Foxground and Berry bypass

Princes Highway upgrade

Submissions report

MAY 2013

Figure 2-1 Short listed route options

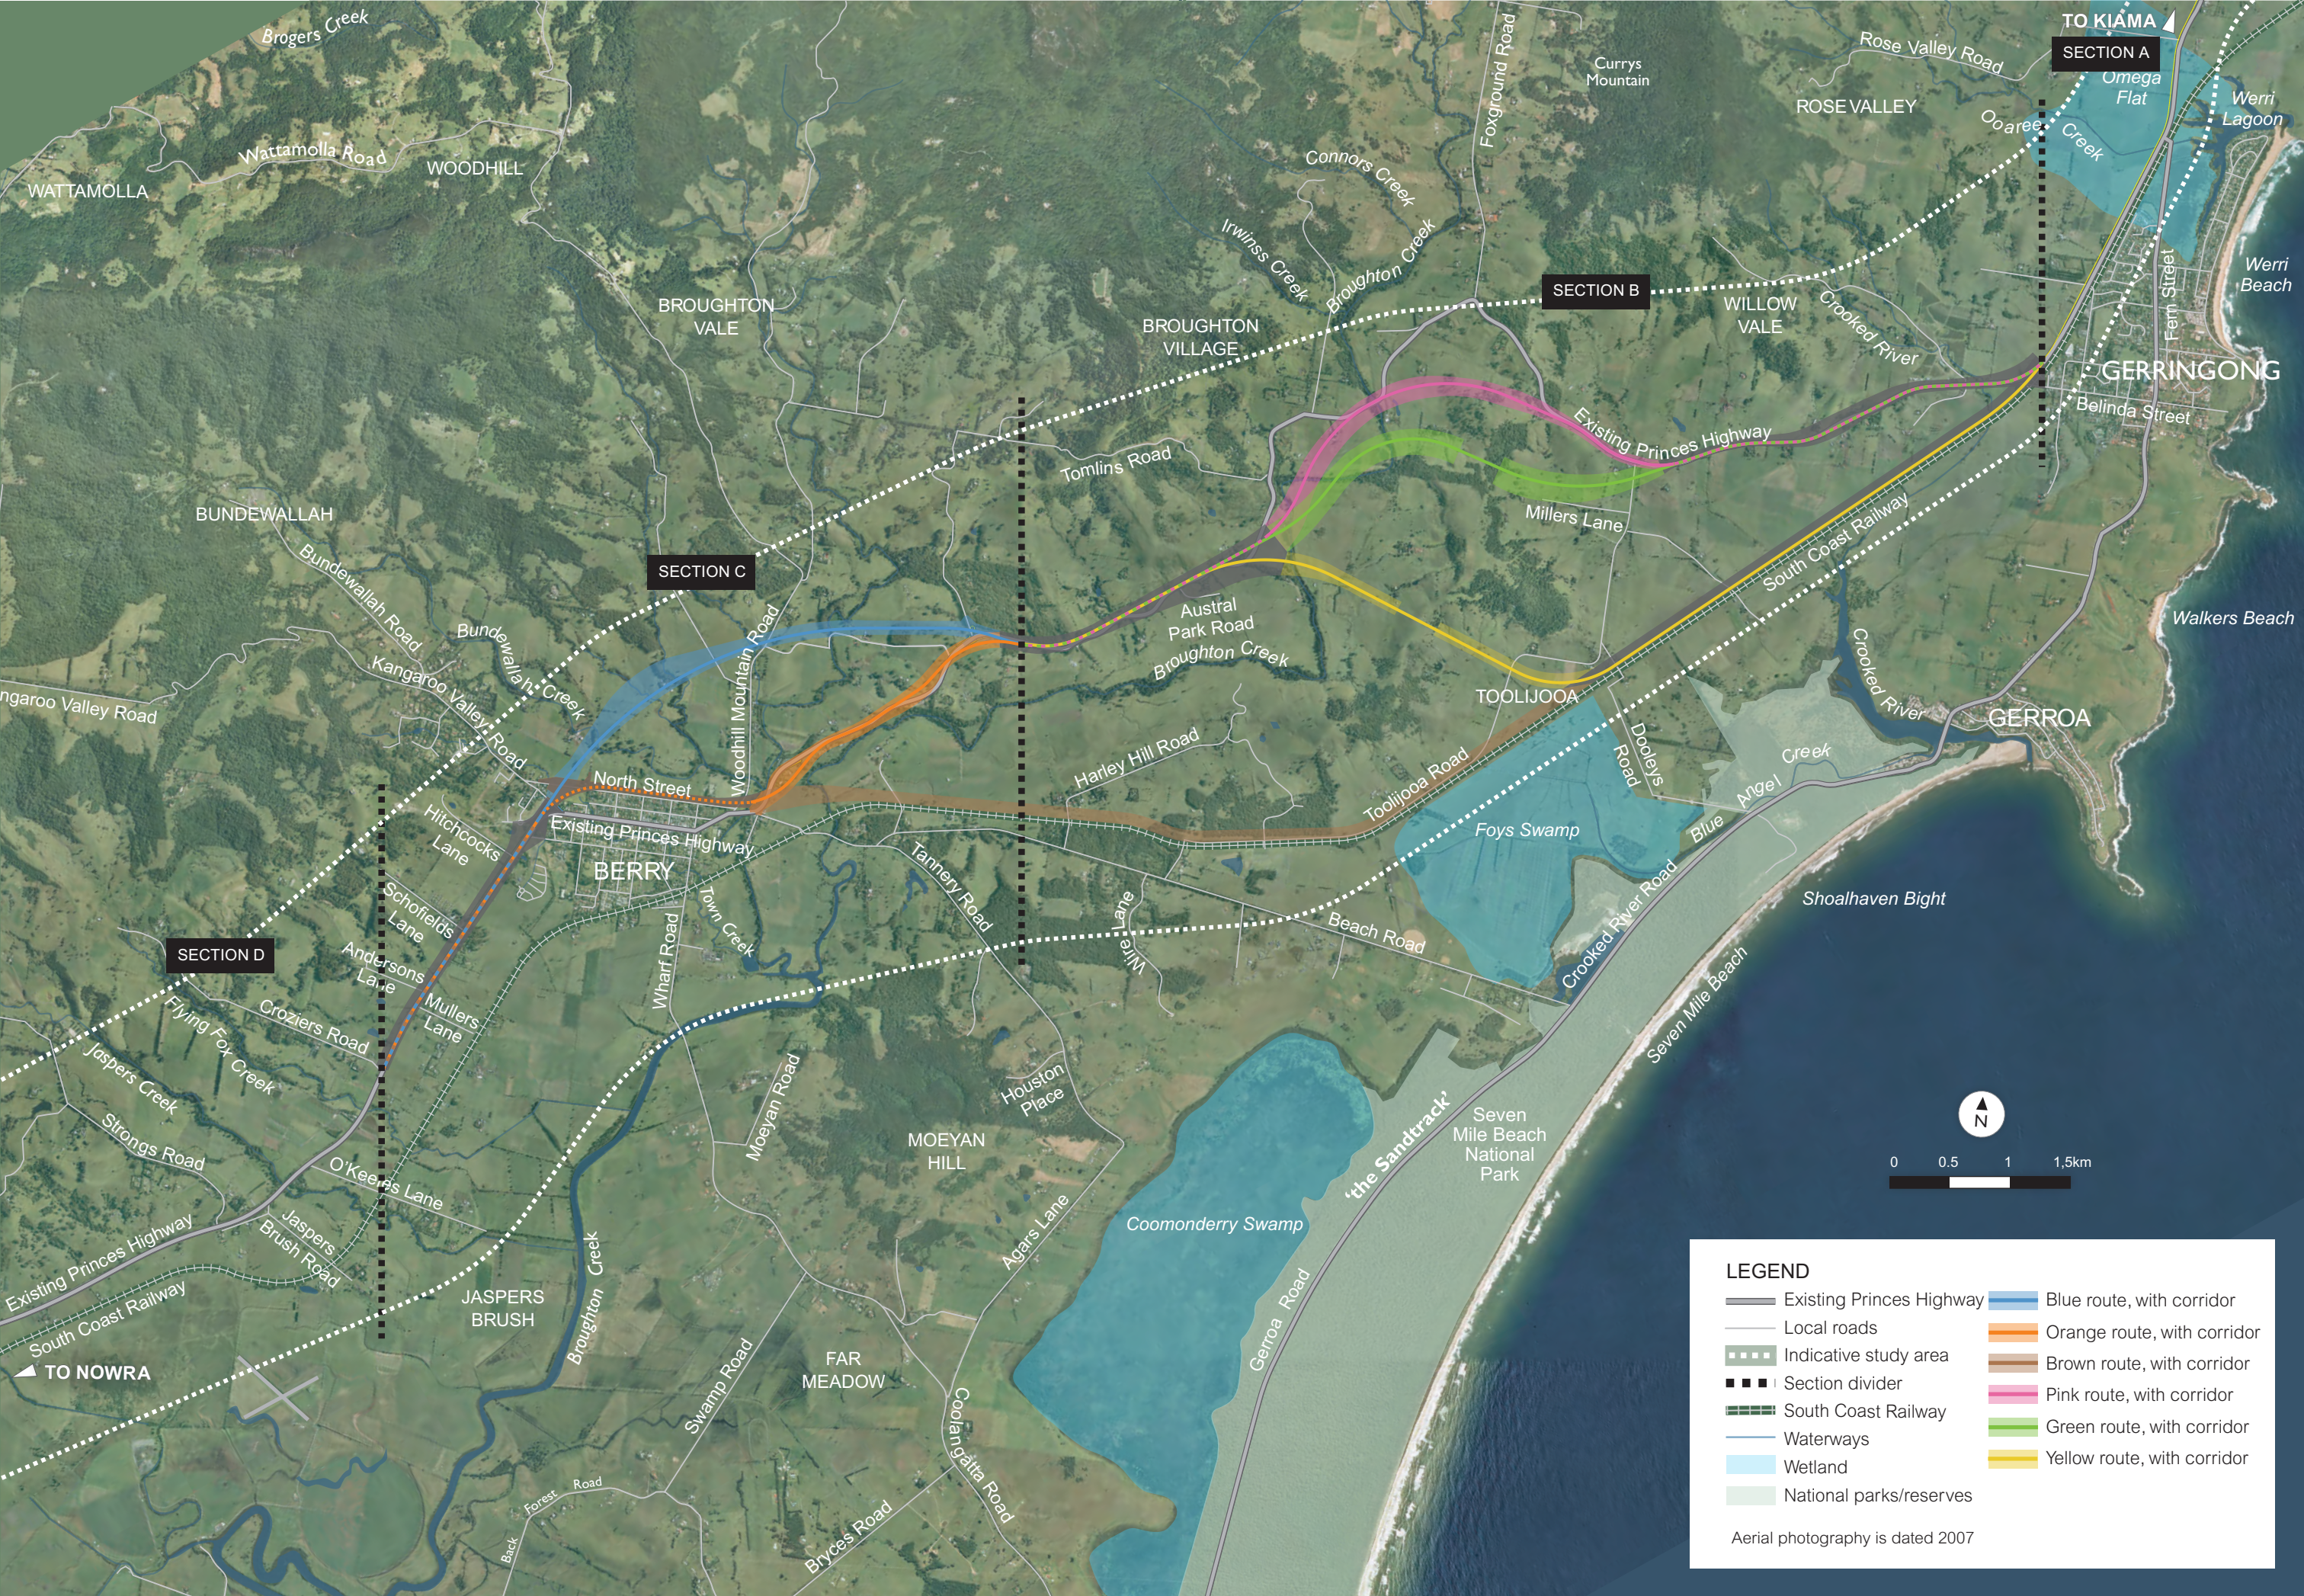
Support for the orange route option was noted by RMS. A modified orange option was adopted by RMS as the preferred option following community consultation undertaken as part of the value management workshop process.

Objections to the blue and yellow options were noted by RMS. These options were not carried forward due to the reason presented in the submissions.
